PROJECT: **Campbell Barn Site Improvements
Maine Bureau of General Services**

DATE: **10 November 2015**

The following revisions, additions, deletions, and/or clarifications are made to the Proposal and Contract Documents:

Title
LAYOUT AND GRADING PLAN

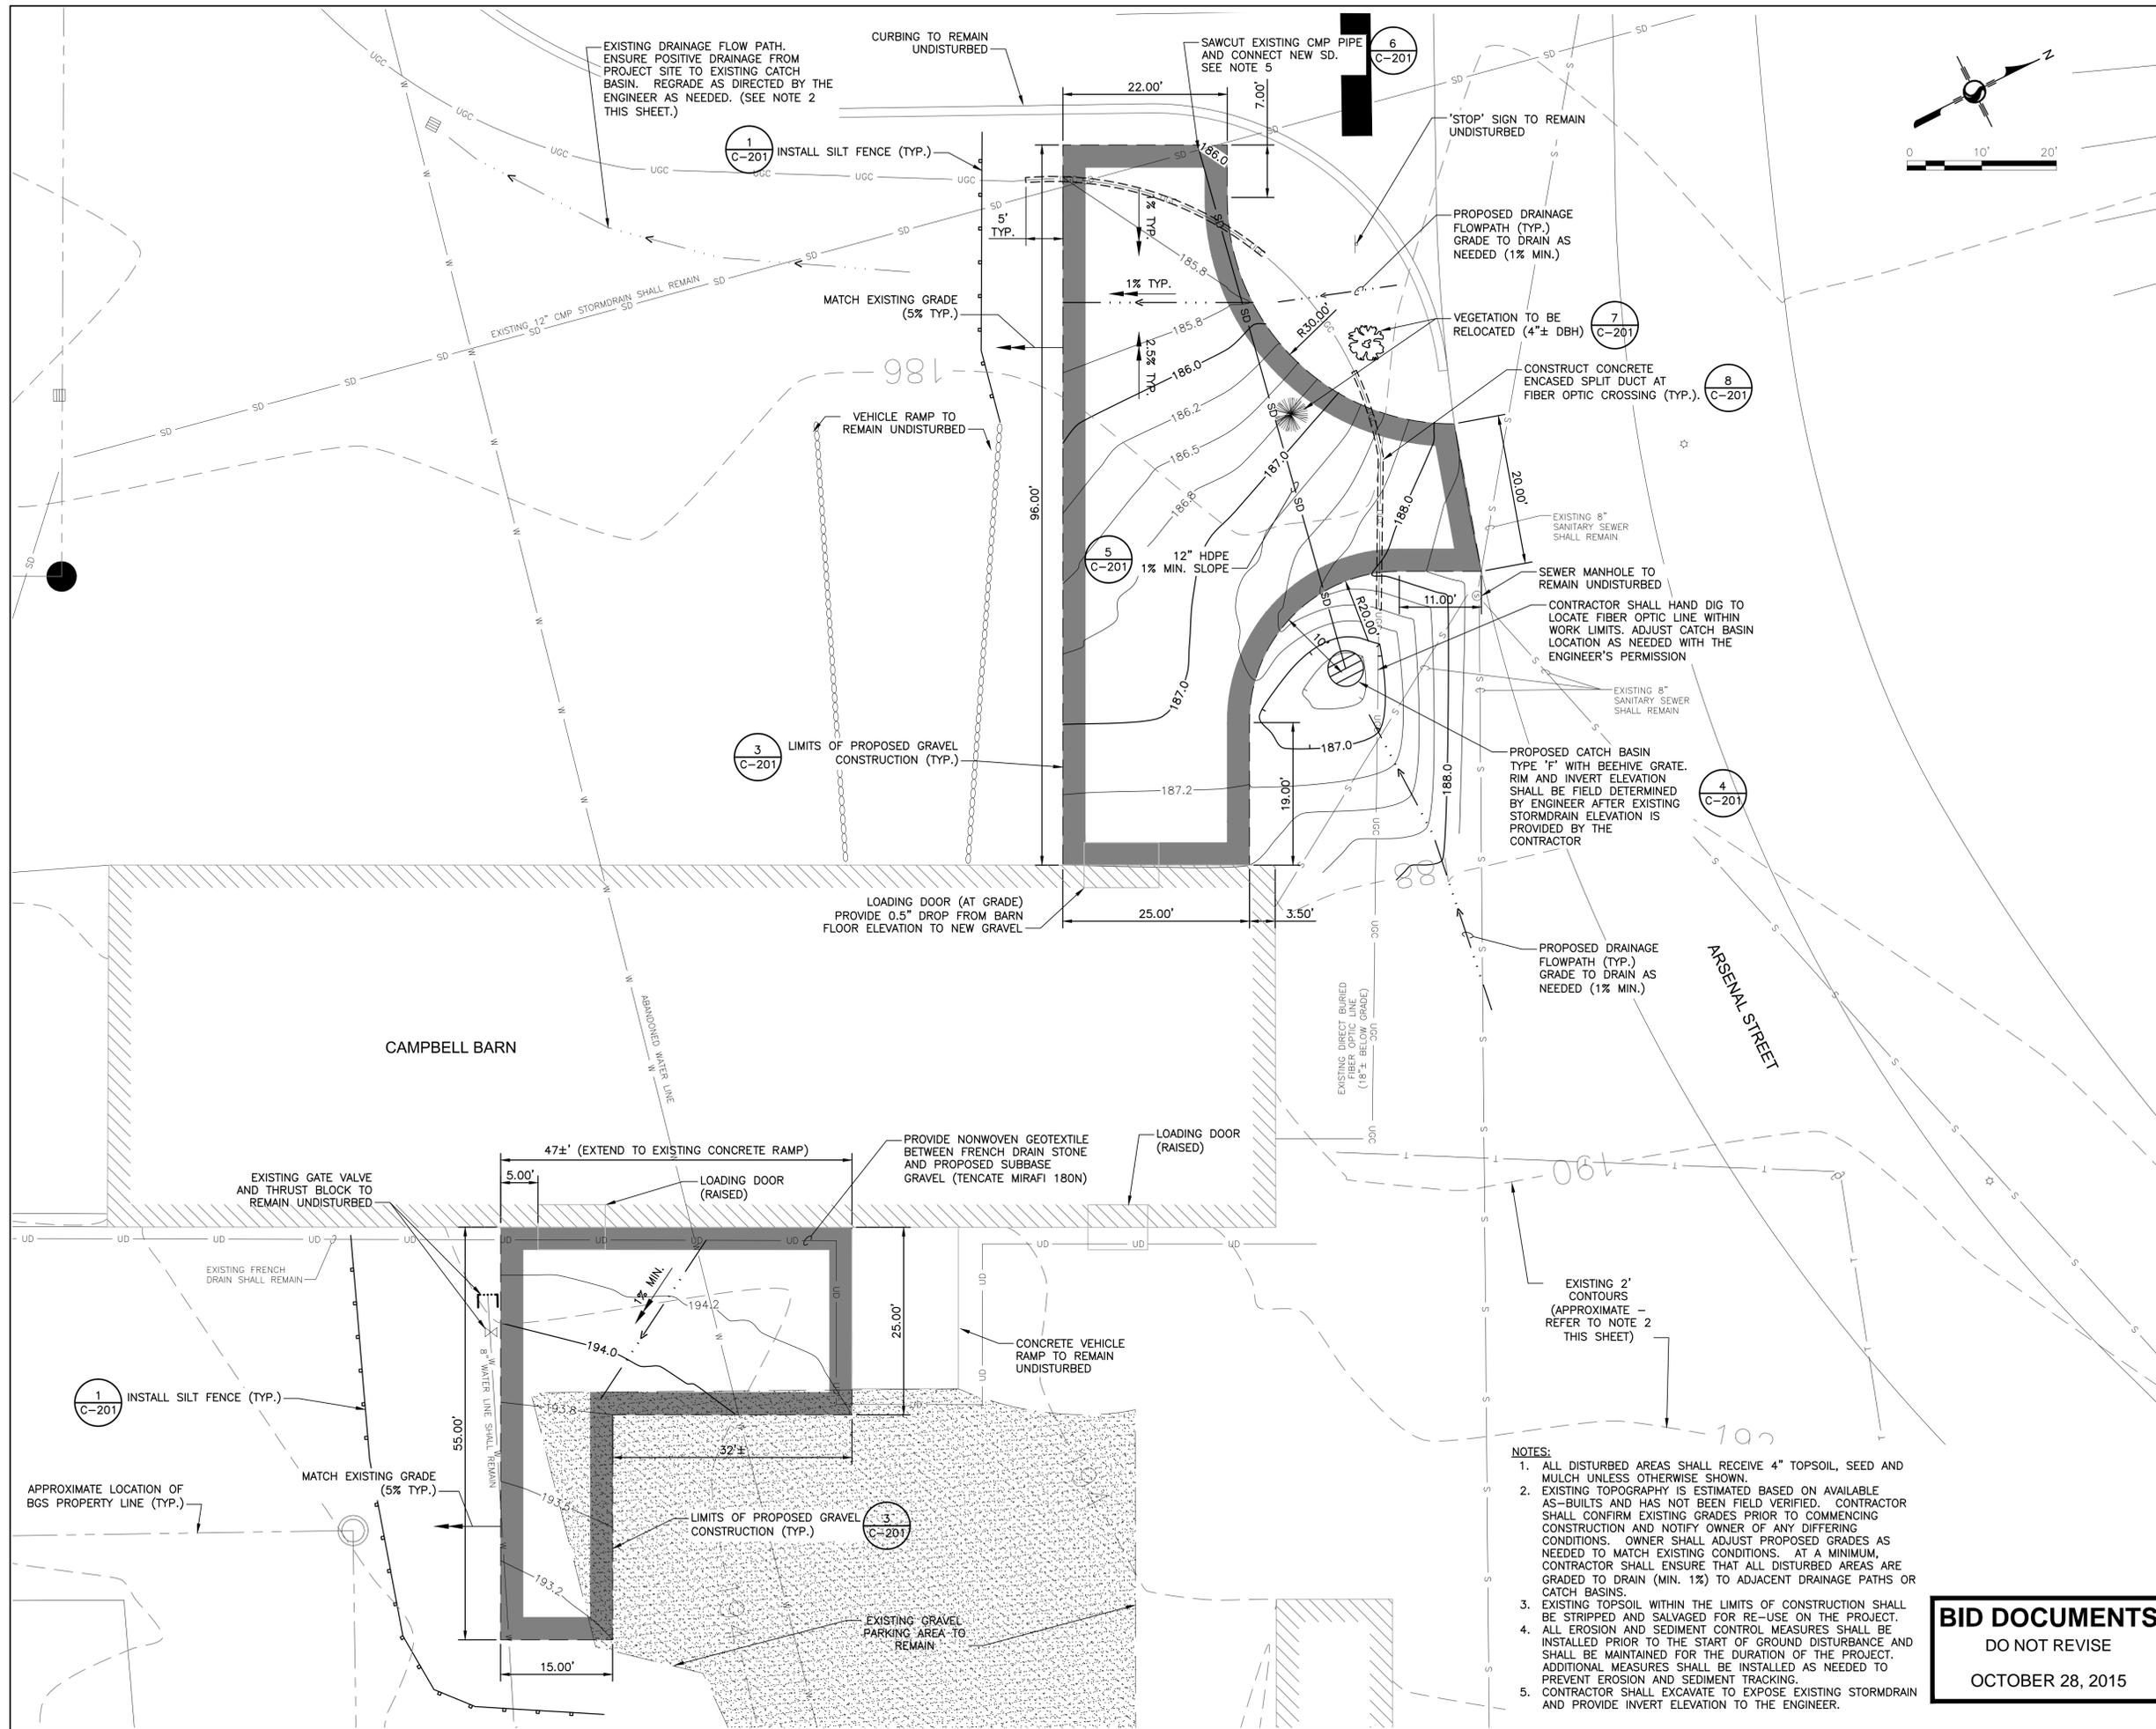
2. **Question:** *Each of the work areas shown on C102 has one existing contour shown, but they are not labeled. Please clarify what those elevations are.*
Answer: Refer to attached drawing C-102 *Layout and Grading Plan, Revision A* which identifies the existing 2-foot contours running through the site. This elevation data is approximate and shall be confirmed by the Contractor prior to construction. Refer to note #2 on attached drawing C-102 *Layout and Grading Plan, Revision A*.

A. REVISED PER ADDENDUM NO. 1 DPN DPN 15.11.10
Revision By Appd. YY.MM.DD
